INITIAL FIRE SAFETY INSPECTION REPORT

Sustainable Wet Processing Plant Ltd.

RSC ID: 26543

Date: 17-December-2025

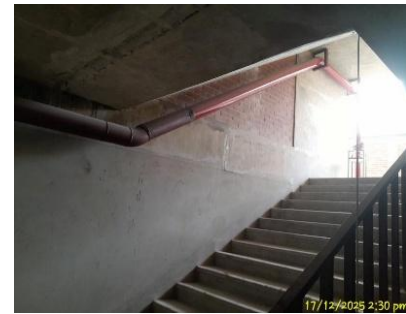
F-11	Means of Egress	<p>Aisles were found missing in several locations throughout the building.</p> <p>Location(s): 1st & 2nd floor, Production Building.</p>	<p>Provide minimum aisle widths of 36-in. Aisles mark shall be clearly visible.</p>	<p>Within 3 Months</p>
------	-----------------	---	---	------------------------

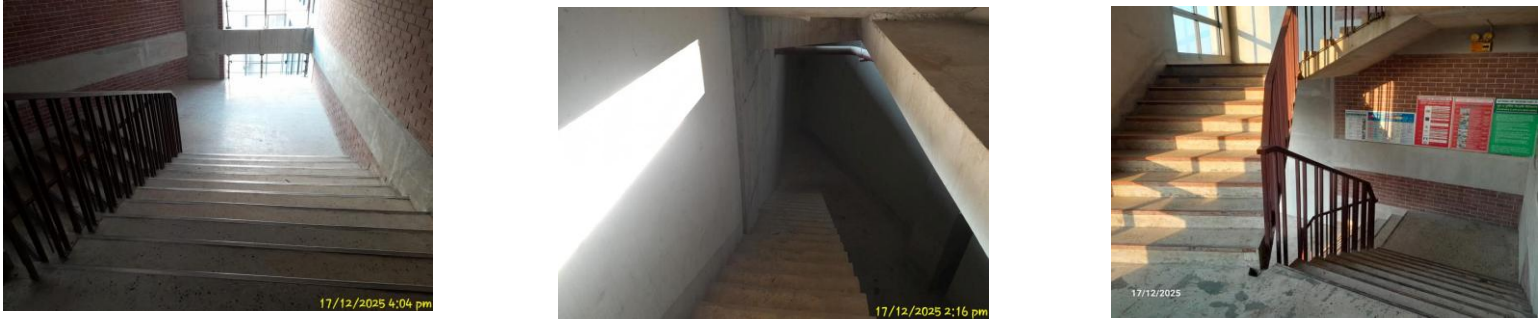
F-13	Means of Egress	<p>The maximum travel distance exceeds 30 m, which does not meet the requirements of Section 6.13 of RSC Technical Guidelines (Standard).</p> <p>Location(s): Basement Store area. Production Building.</p>	<p>Reconfigure the egress arrangement to meet 6.13 of RSC Technical Guidelines (Standard).</p> <p>Or,</p> <p>Provide additional exits so that the travel distance shall not exceed the maximum allowable limit.</p>	Within 3 Months
 <p><i>December 17, 2025 2:19 PM</i></p>		 <p><i>17/12/2025 2:37 pm</i></p>

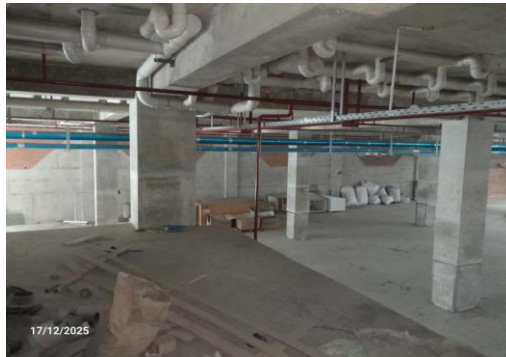
F-18	Means of Egress	<p>Stair clear width was found less than 60 in.</p> <p>Location(s): South East stair of Basement, Production Building.</p>	<p>Stairs shall have a minimum clear width of 60 in. for all industrial occupancies as per RSC Technical Guideline (Standard) section of 6.5.6.</p>	<p>Within 3 Months</p>

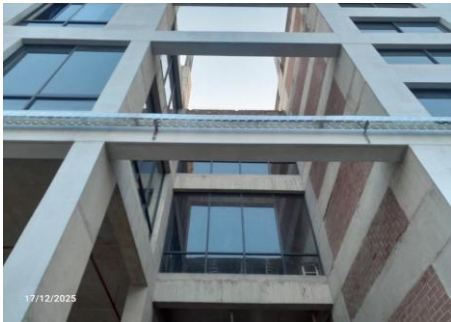
<p>F-31</p>	<p>Fire Rated Construction</p>	<p>Penetrations through floor/ceiling assemblies are found unsealed due to BBT & cable tray passing, floor punch for metal pipes, floor punch for construction purposes, etc.</p> <p>Location(s): All floors, Production building.</p>	<p>Seal all penetrations and openings in floor/ceiling assemblies by a listed through-penetration fire stop system tested in accordance with ASTM E814 or approved alternative standard to maintain a minimum 3-hr. fire resistance rating. Installation shall be as per the manufacturer's published installation guideline and the certification authority guideline to ensure the fire-rating in accordance with section 4.7 of RSC Technical Guideline (Standard)</p> <p>Or,</p> <p>Provide a minimum 2-hour fire-rated shaft to separate the penetration from each floor if required.</p>	<p>Within 3 Months</p>
--------------------	--------------------------------	---	--	------------------------

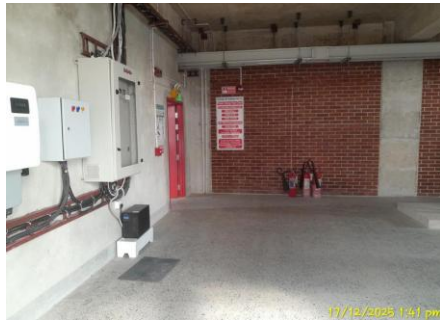
F-52	Means of Egress	<p>Based on the number and location of emergency lights observed, adequate illumination levels are not anticipated along egress routes.</p> <p>Location(s): All floors (Utility Building).</p>	<p>Test the emergency lighting system on each floor and provide additional emergency fixtures to provide adequate illumination along the means of egress. Provide a minimum illumination of 10 lux at the floor level within exit stairs and exit discharge paths, and minimum 2.5 lux along exit access aisles. Illumination on means of egress shall meet in accordance with RSC Technical Guidelines (Standard)¹ V1.0 Section 10.12.2.</p>	Within 3 Months

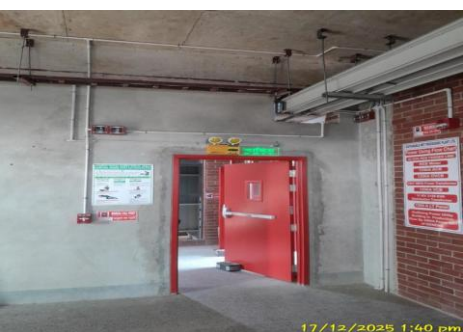
F-55	Means of Egress	<p>Exit stair(s) terminate the occupants inside the building, which does not comply with section 6.17 of RSC Technical Guidelines (Standard)¹ V1.0.</p> <p>Location(s): West Stair (due to inaccessibility towards the discharge path); Utility Building.</p>	<p>Exits shall discharge directly to the exterior of the building unless meeting the requirements of 6.17.2 or 6.17.3 as per RSC Technical Guidelines (Standard)¹ V1.0.</p>	<p>Within 3 Months</p>
------	-----------------	---	--	------------------------

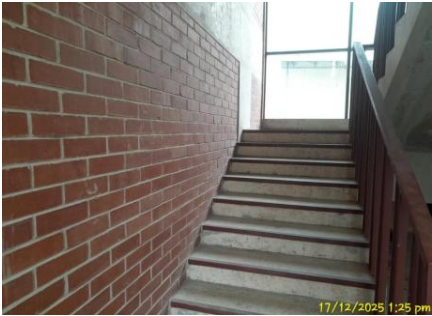
F-57	Means of Egress	<p>Unsealed penetrations and openings are located in exit stair enclosures. Electrical cable/ BBT raceway passing through the exit enclosure.</p> <p>Location(s): West stair, Utility Building.</p>	<p>No other penetration into and through the exit enclosure except for fire alarm equipment electrical raceway, required exit doors, sprinkler piping, standpipes, and electrical conduit serving the exit enclosure is permitted in accordance with section 6.14.4 of RSC Technical Guidelines (Standard)¹ V1.0. So, relocate the electrical wires/raceways to somewhere else avoiding the exit enclosure, and seal the created unprotected openings with a minimum of 1.5 hours listed/certified fire-rated materials. Installation shall be as per manufacturer published installation guideline and the certification authority guideline to ensure the fire-rating. Or seal the penetration by 2-hr masonry construction.</p>	Within 3 Months
